silnik do MP100D Makita TE00000640 (TE00000478)

Y08765

Title	Change of Motor assembly with Air pipe assembly
Model	MP100D
Country	All countries
Description	[1][2] Air pipe assemblies for production have been unified to ø6mm thread type. [3][4] Motor assembly for production have been changed according to [1][2]. Note: There is no difference in performance between ø6mm thread type and ø8mm thread type. However, the repairs are different. See below.

ø8mm thread ø6mm thread

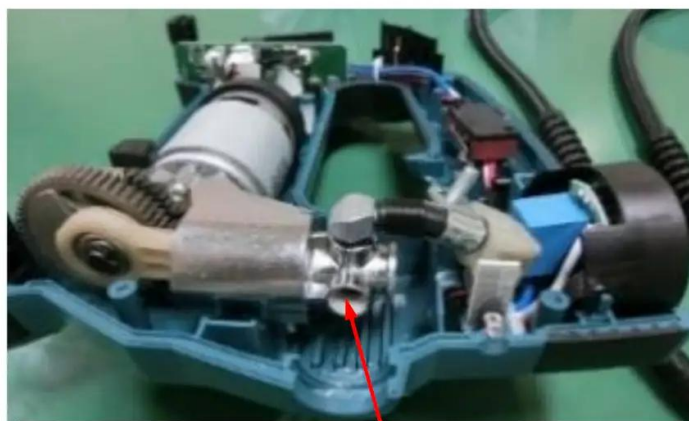
Current Air pipe assembly has either ø8mm or ø6mm threaded air pipe end as shown above.

New Air pipe assembly has the only ø6mm threaded air pipe end.

Only Air pipe assembly wants to be replaced;

Check the thread diameter of the machine that the customer repairs, and order the same Air pipe assembly.

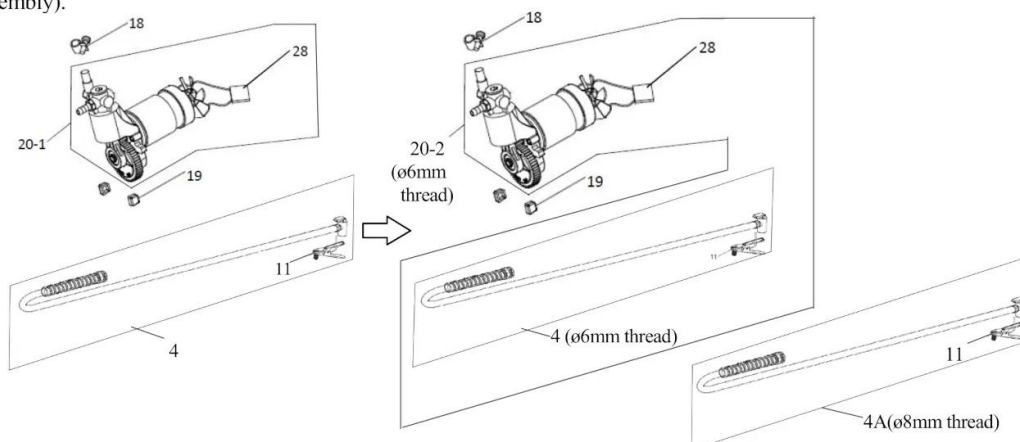
Current Motor assembly has either ø8mm or ø6mm thread joint portion.

New Motor assembly has the only ø6mm thread joint portion.

Motor assembly wants to be replaced;

Because of parts unification to ø6mm thread type, order the new Motor assembly (with ø6mm thread Air pipe assembly).
